Here are some assembly / design comments and questions.

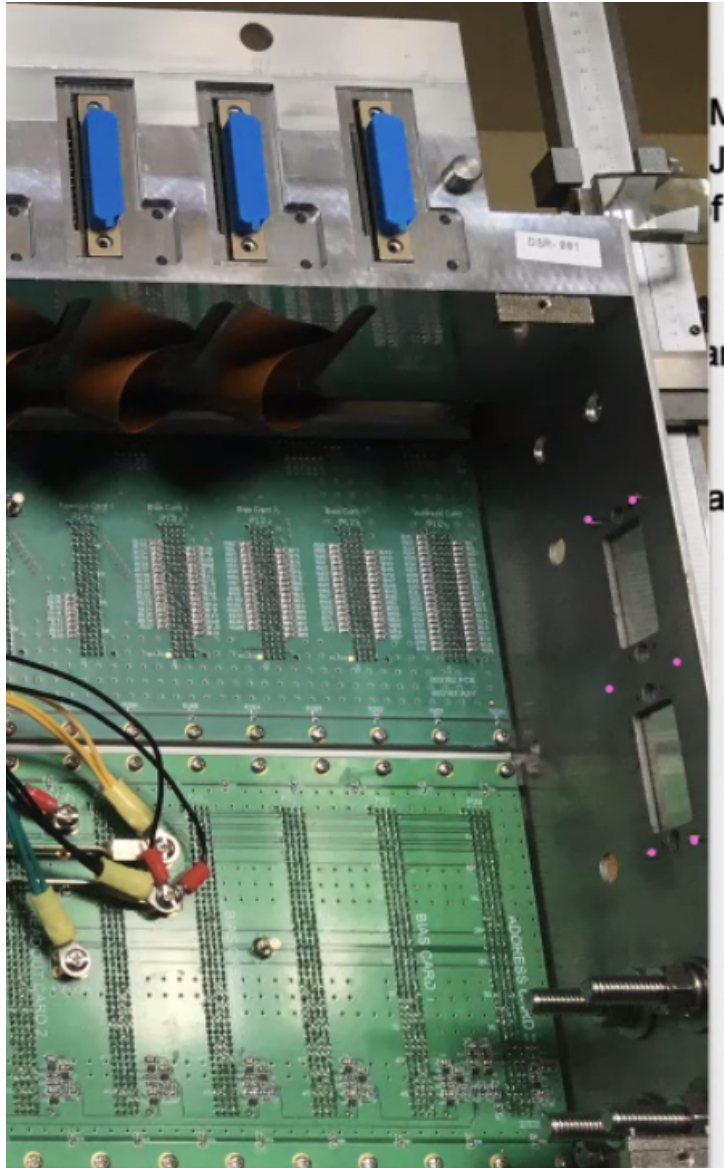
- Dmce6 shows the assembled unit.
- dmce1

shows the two Hirose clamps. I smoothed all sharp corners. -- MA : aka retainer bar
I also trimmed the height of the back riser to be half. This is to reduce how much the clamps push the flex around.

While installing I notice the holes are drilled in the wrong place, allowing the clamp to be pushed in too far, again, disturbing the flexes. Also, the wiring harnesses slightly get in the way of tightening the clamps, so maybe easier to do the clamps before the harnesses.

shows the bottom and the back. I have replaced the string of stock edge/corner pieces with single long rails, and I like how this works.

1. The balance point is just at the edge of the handles. It requires quite a bit of torque to hold the electronics for mating to a cryostat.
Lightening the filter rail assembly will help, but let's move the handle to the rear few cm.
2. the front bracket only uses two bolts for attachment and that is sufficient. Let's only use two for the rear.
3. The rear bracket should be modified to include a leg. Just extend the body down to the right place.
4. The handle, when stowed, interferes with the ground lug. Let's move the lug.

The bolts attaching the rear bracket to the body interfere with use of the bracket. Swap use of 8mm socket head bolts to 5mm flathead.

Notice that the bolts holding the back in place stick out past the plane of the brackets and connectors. This must be a bad idea!

There was not a place to bolt the back panel to the sides. I folded the back, and this seems to work very well.

The top and bottom panels simply end at the top and bottom rittal rails. It would be nicer if they end in a fold, as in the Rittal diagrams.

2021-04-12 After BICEP check

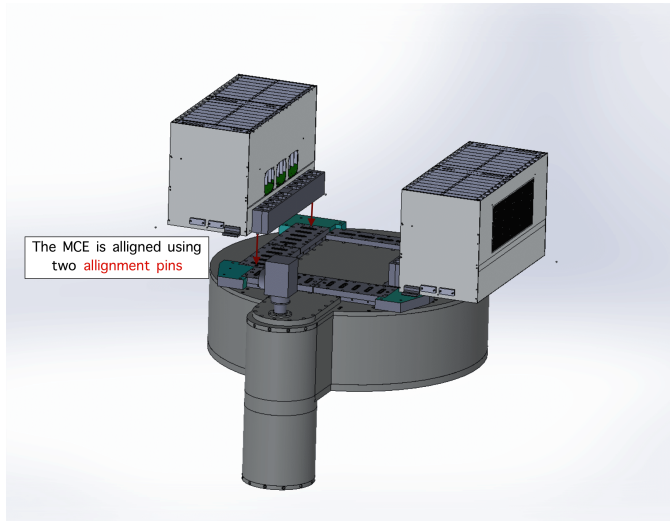
- hole for one foot interferes with the cryostat bracket (foot on the power connector side and hole closer to the connector)
- cryostat mounting ear holes need to be moved to the other side of the connector in the SW model.
- hard to mount: discussion with bicep is called for whether we can make changes to facilitate mounting on cryostat. no change on the mce for now. MH/SF will provide a mounting recipe to Lorenzo
